## HISTORIC AND DESIGN REVIEW COMMISSION

May 03, 2017

**HDRC CASE NO:** 2017-210  
**COMMON NAME:** 610 N MAIN  
**ADDRESS:** 615 SOLEDAD ST  
**LEGAL DESCRIPTION:** NCB 141 (MAIN & GIRAUD), BLOCK LOT 19  
**ZONING:** D, RIO-3  
**CITY COUNCIL DIST.:** 1  
**APPLICANT:** Demetrio Macris/Soledad Realty, LTD  
**OWNER:** Demetrio Macris/Soledad Realty, LTD  
**TYPE OF WORK:** Exterior modifications, addition of curtain wall glass system, addition  
**REQUEST:**

## PVA - WEST ELEVATION

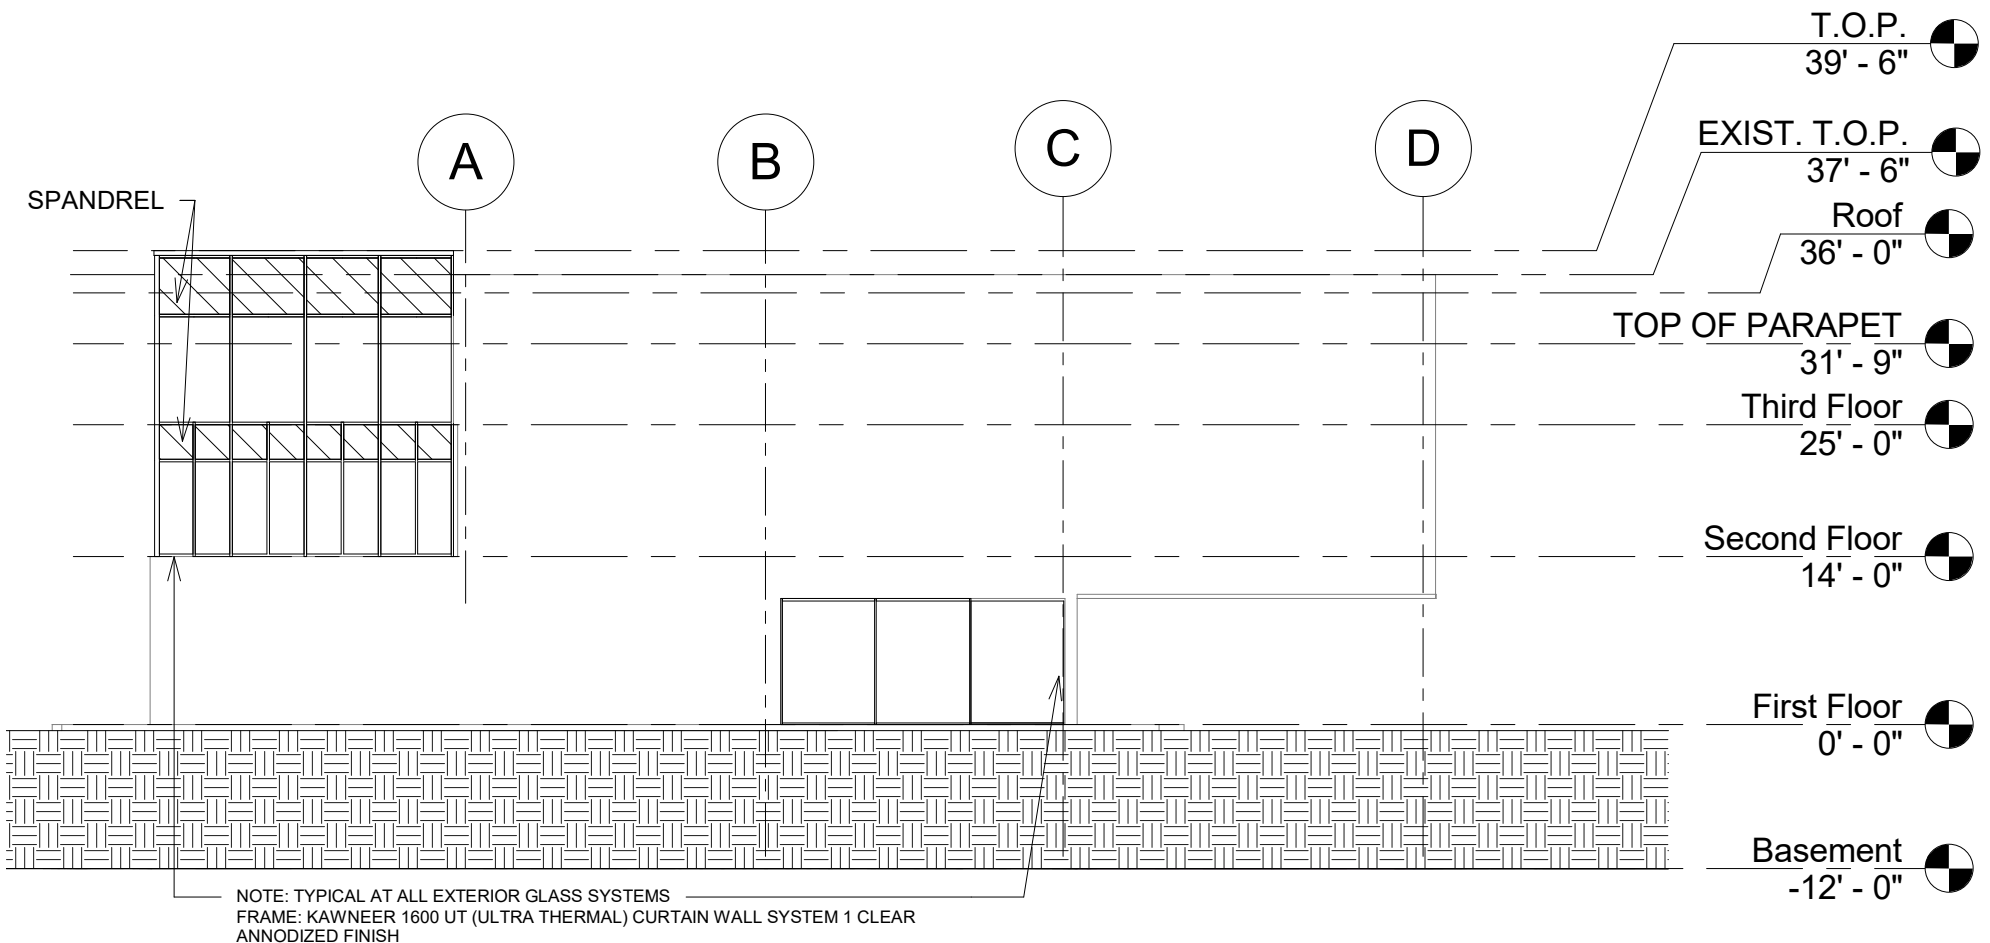
- c. WINDOW REPLACEMENT – The structure currently features tinted glazing which the applicant has proposed to remove and replace with a clear, anodized aluminum storefront system. Staff finds that the proposed glazing should not feature a tint that is darker than the currently glazing.

Staff recommends approval based on findings a through c with the stipulation that the proposed new glazing does not feature a tint that is darker than the current tint.

## PVA - SOUTH ELEVATION

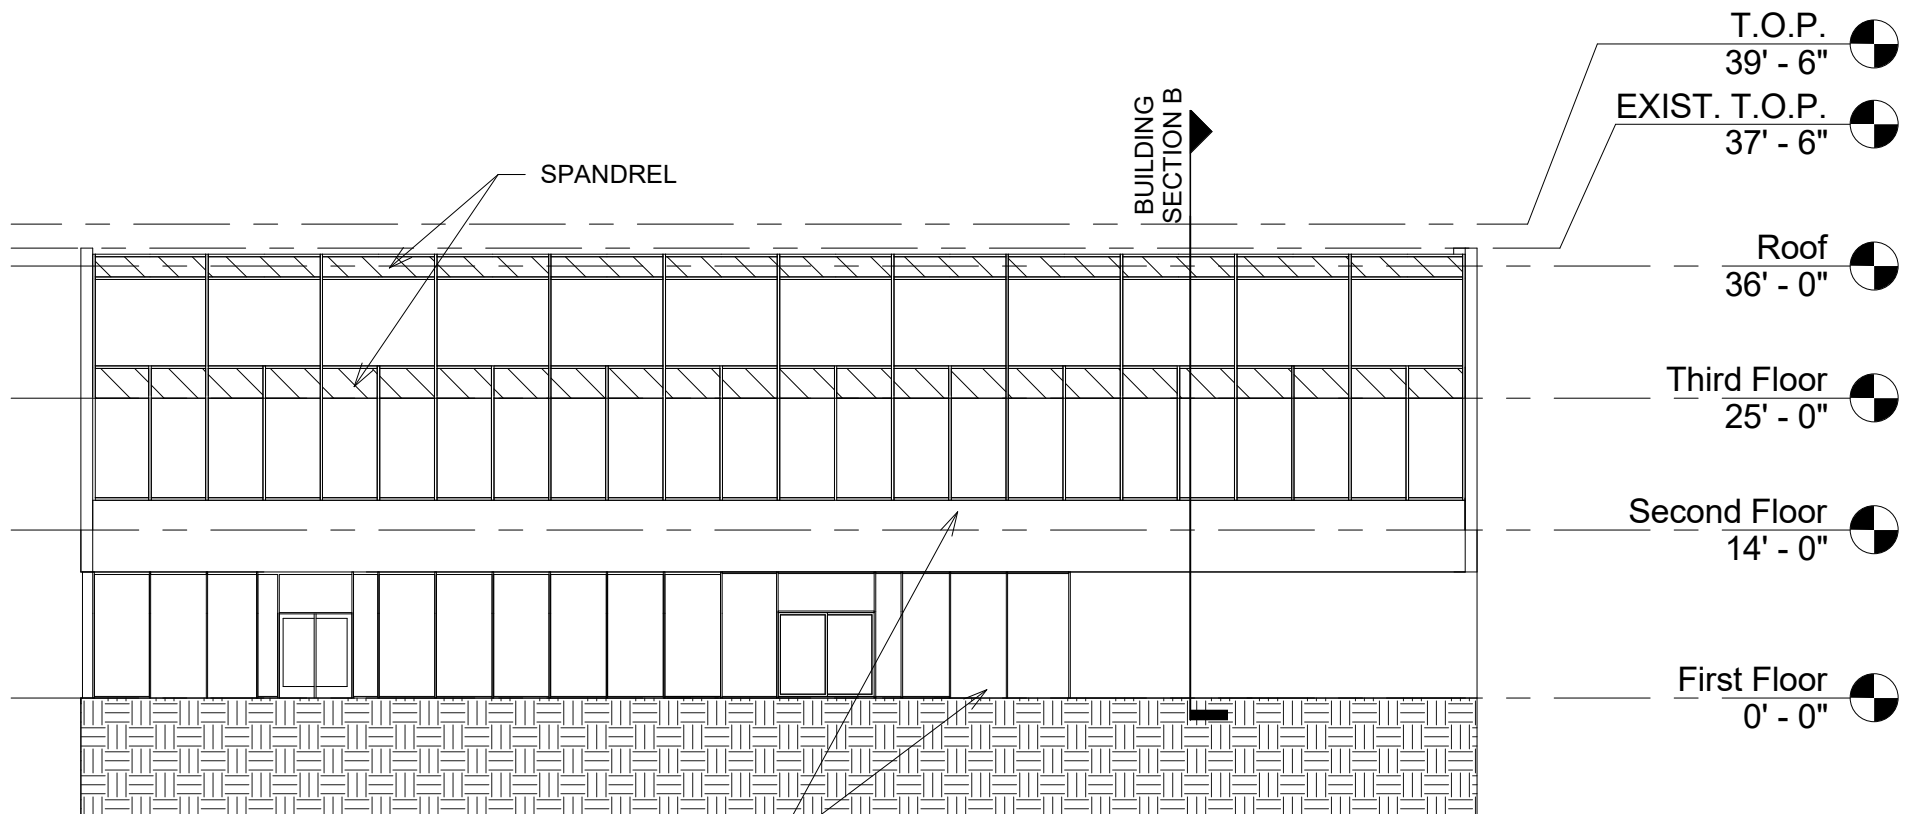
- b. ADDITION – On the southern façade of the existing structure, the applicant has proposed to enclose an existing, open air patio space. The proposed addition will be constructed to be flush with the existing ground and upper level southern walls. The original structure features Brutalist style architecture and primary façade materials which include stone cladding. The UDC Section 35-676(b) notes that the distinguishing original qualities or character of a building, structure, object, or site and its environment, shall not be destroyed. The removal or alteration of any historic material or distinctive architectural features shall be avoided when possible. Staff finds the applicant's proposal appropriate and consistent with the UDC.
